2019-05-29

Subject: 91 and 131 Eglinton Avenue East, and 5055 Hurontario Street Transportation Study - Response to Comments

A Transportation Study was completed by WSP for the subject lands in September 2018 along with a Technical Memo regarding the Belbin Street extension, dated June 2018. Subsequently, comments were received from the City of Mississauga, dated February 6th, 2019, which are provided in **Attachment 1**. WSP discussed the transportation comments with the City on March 16, 2019 and the approach for addressing them. The brief synopsis of the discussion is provided in **Attachment 2**. All comments directly related to the September 2018 Transportation Study and June 2018 Technical Memo, as well as comments regarding waste collection (below in red) have been addressed within this letter. The contents of this letter are based on the latest site plan, dated April 24th, 2019, which is provided as **Attachment 3**.

Figure 13
Sightline Analysis - Proposed Northwest Driveway Access on Future Armdale Road
91 Eglinton Avenue East

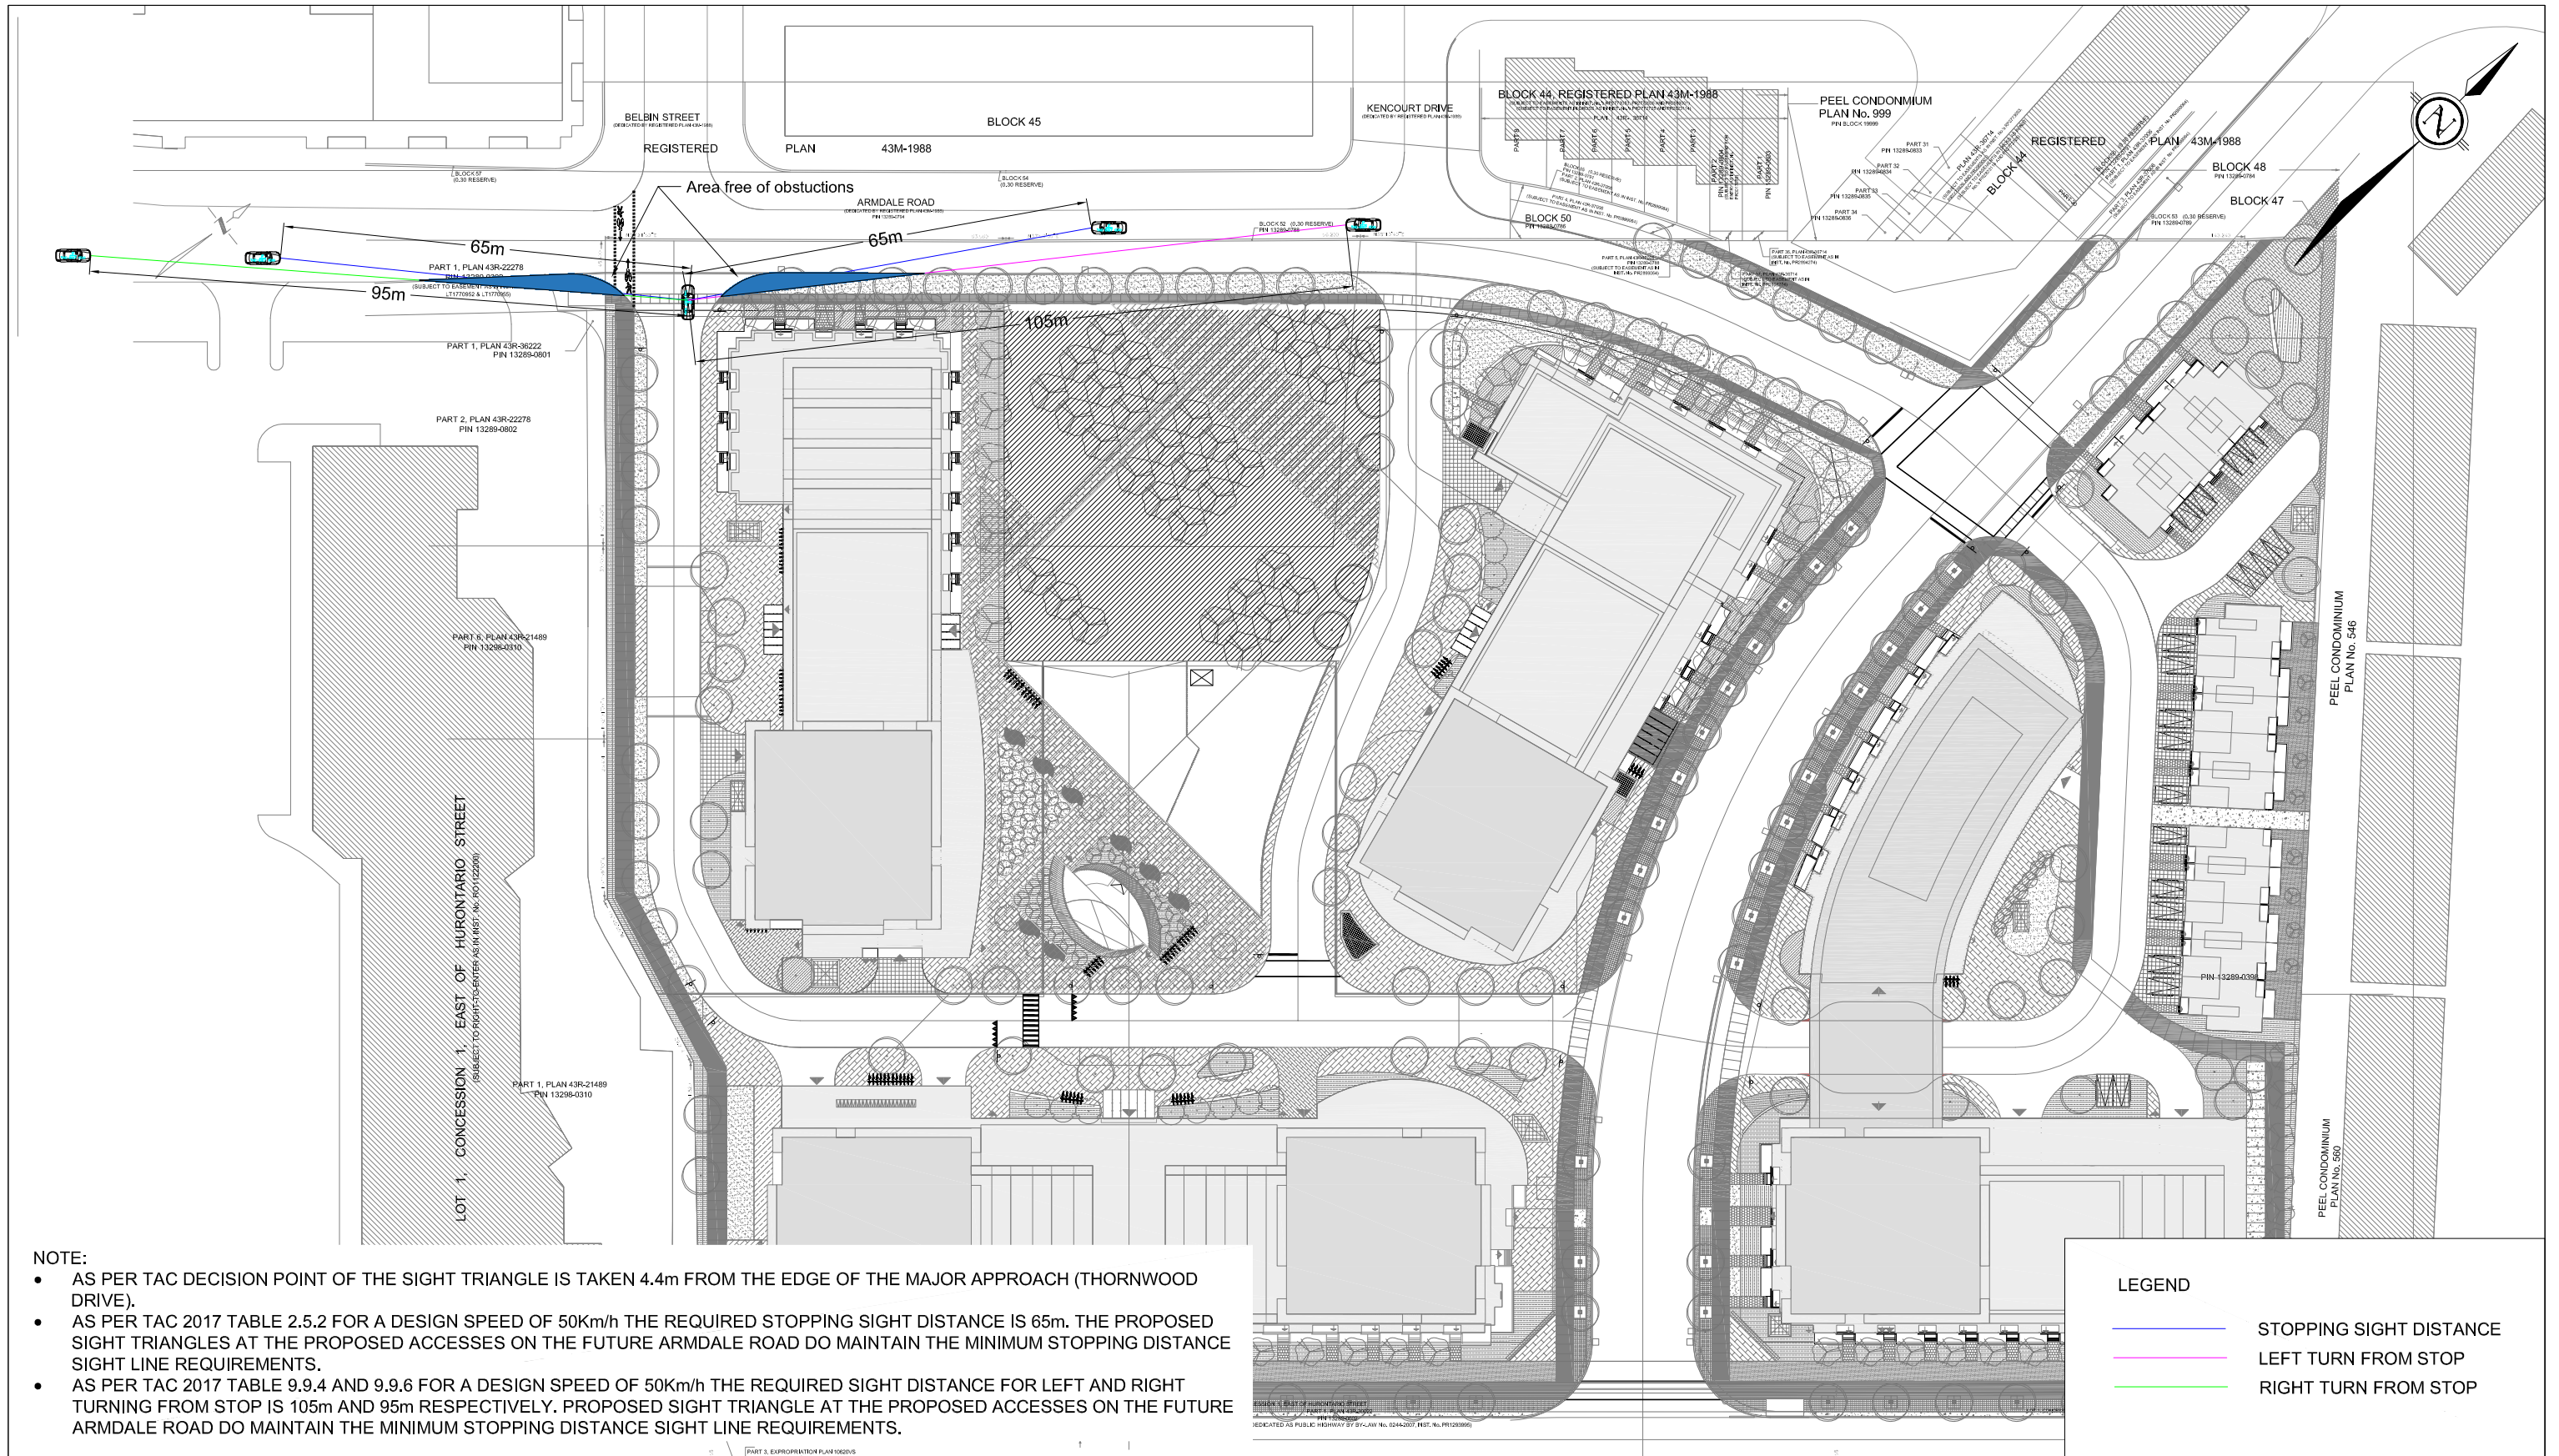
All landscaping and grading within close proximity to the proposed access points is to be designed to ensure that adequate sight distances are available for all approaching and exiting motorists and pedestrians;

Figures 12-14 of Attachment 5 identifies hatched areas that need to be kept clear of all sight line obstructions. Based on TAC Section 8.9.3 it is not necessary to eliminate landscaping from the vicinity of the driveways to provide the required sight distance. Ground cover planting and low shrubs, or trees with high canopies, can be used effectively without affecting the sight lines of the driver.

Figure 15
Recommended Thornwood Drive Extension - Functional Sketch
91 Eglinton Avenue East

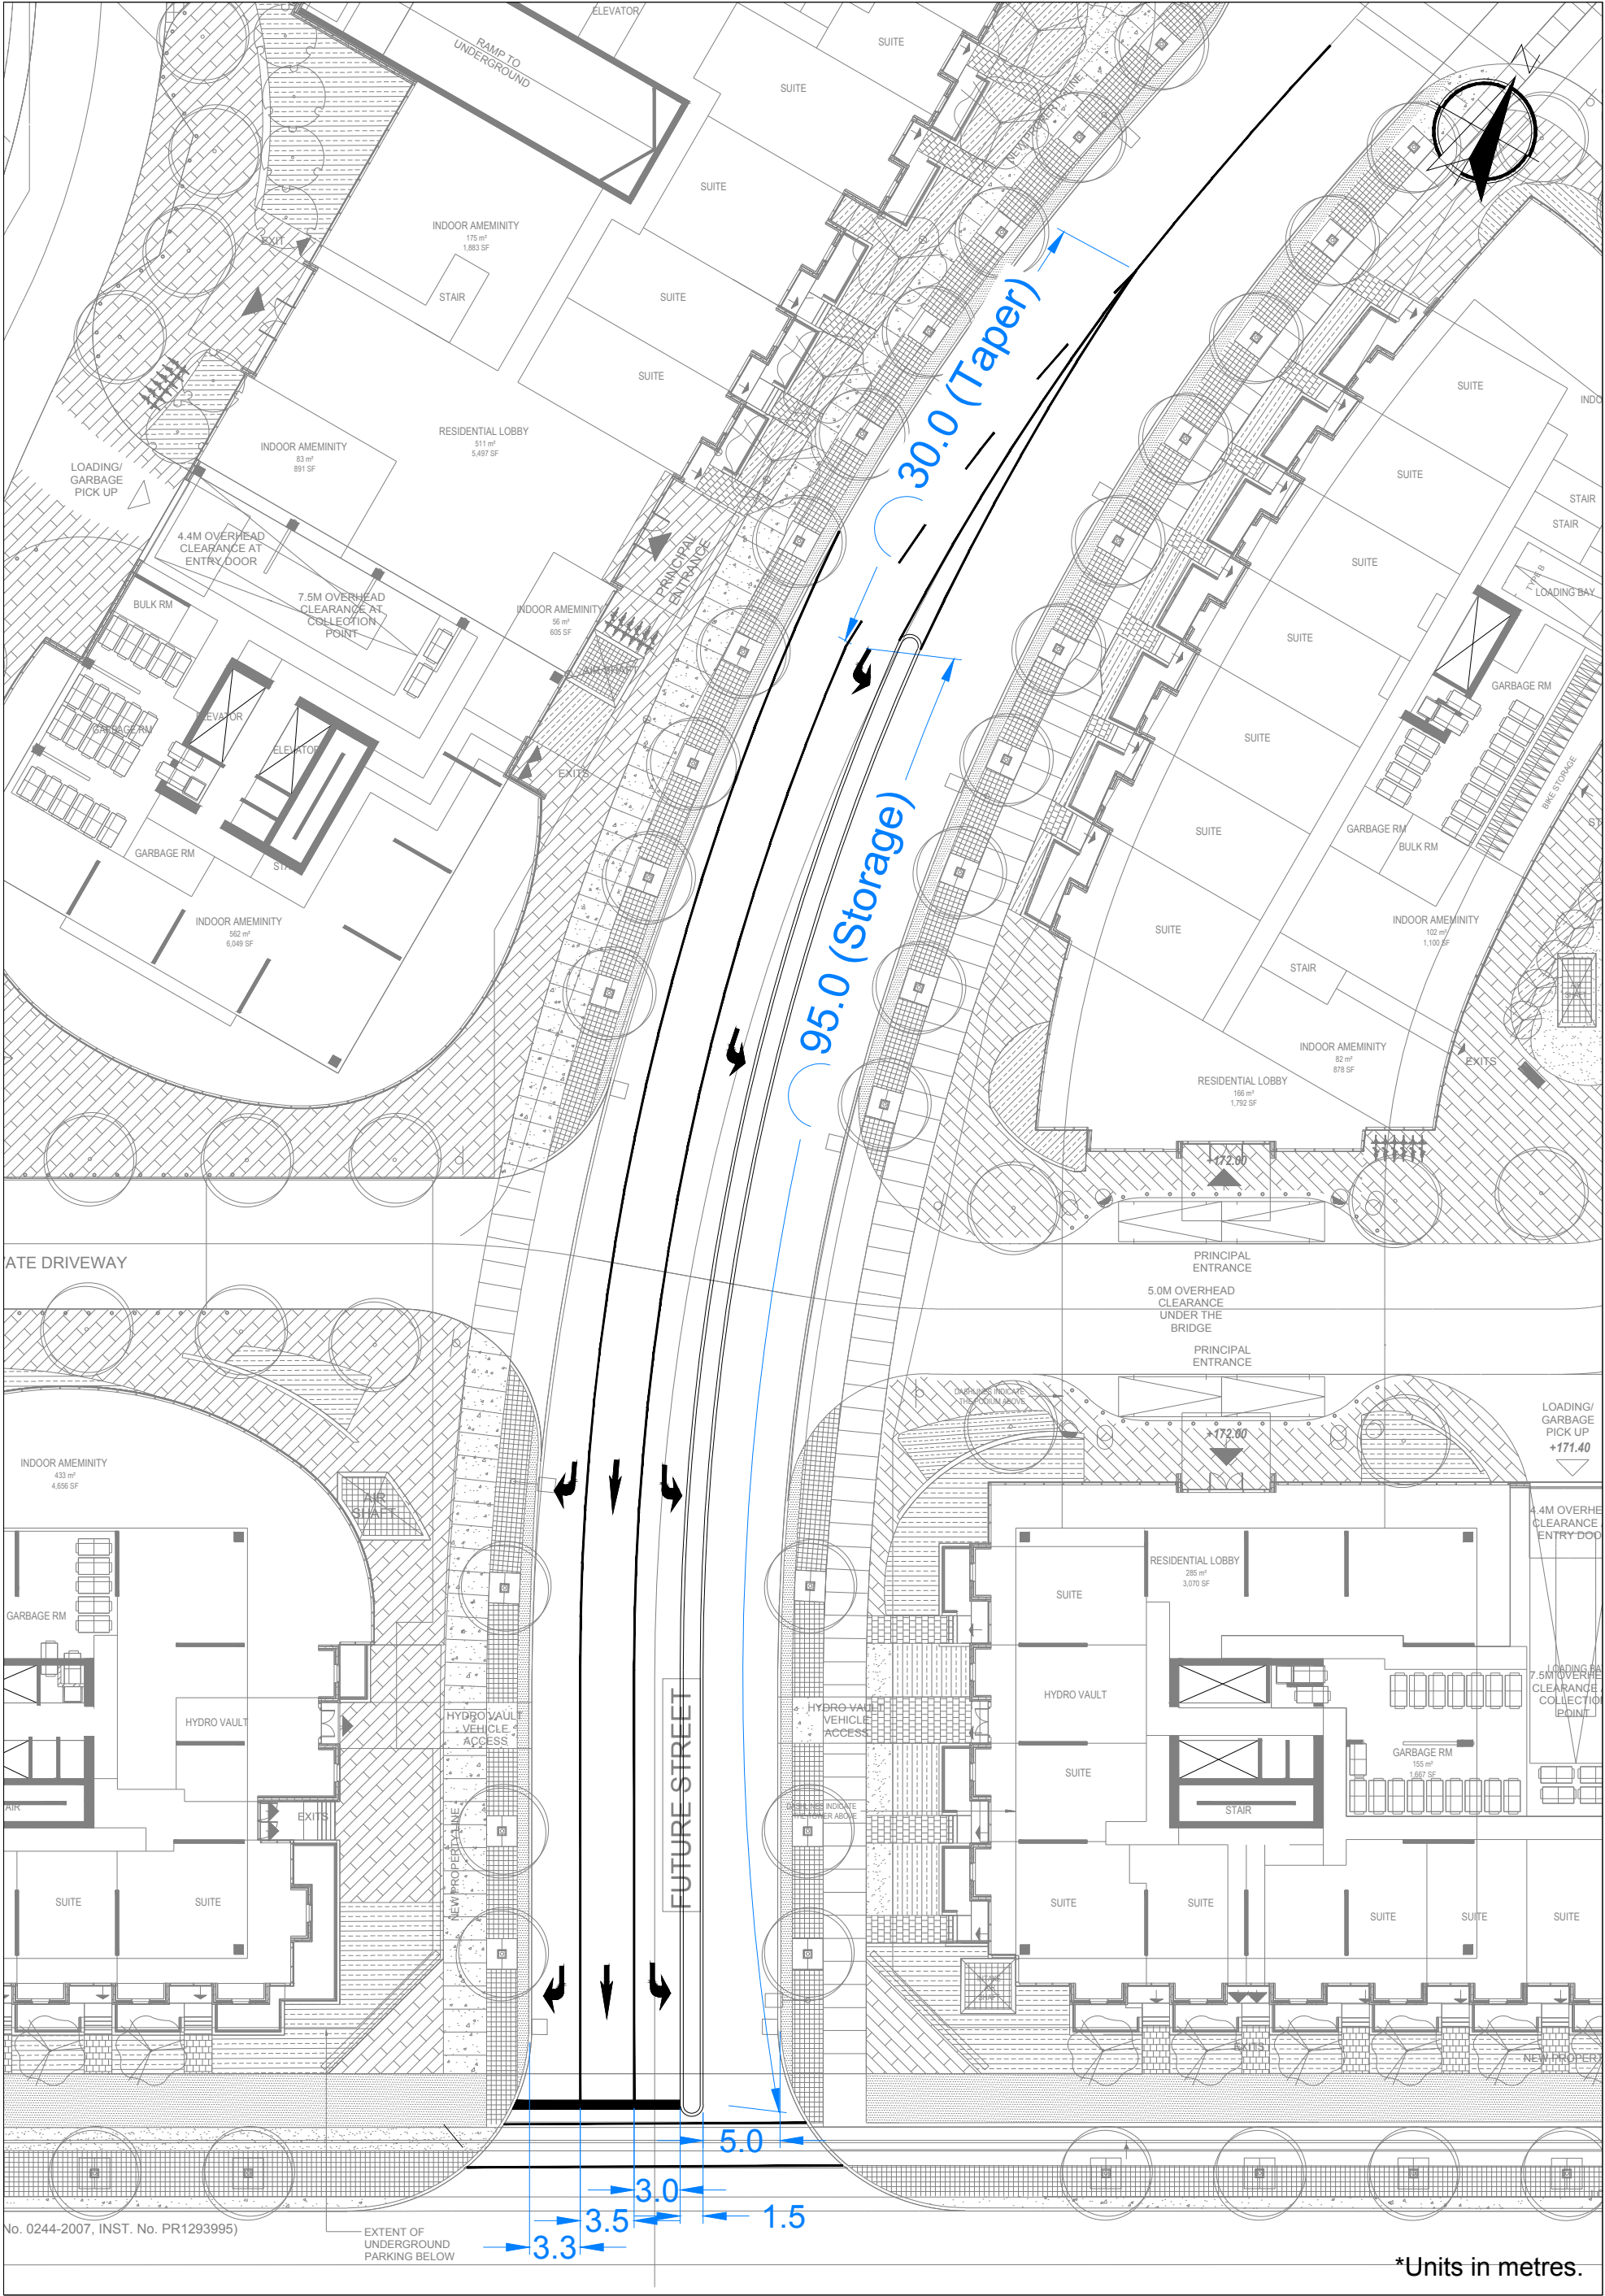
While the urban design panel desired full movements at the site driveways on Thornwood Drive, there would be a number of operational challenges if that was permitted. The proposed driveways are located approximately 55m north of Eglinton Avenue. Given the close proximity, a full moves driveway would result in the following traffic operations challenges:

In addition, there are still sufficient and convenient accesses for vehicular, pedestrian and active transportation movements into and from the site without providing full movements at the driveways on Thornwood Avenue, this includes passenger vehicles as well as larger vehicles such as garbage trucks, fire trucks and moving trucks. The recommended lane configuration at Thornwood Drive and Eglinton is shown in **Figure 15 of Attachment 5**.
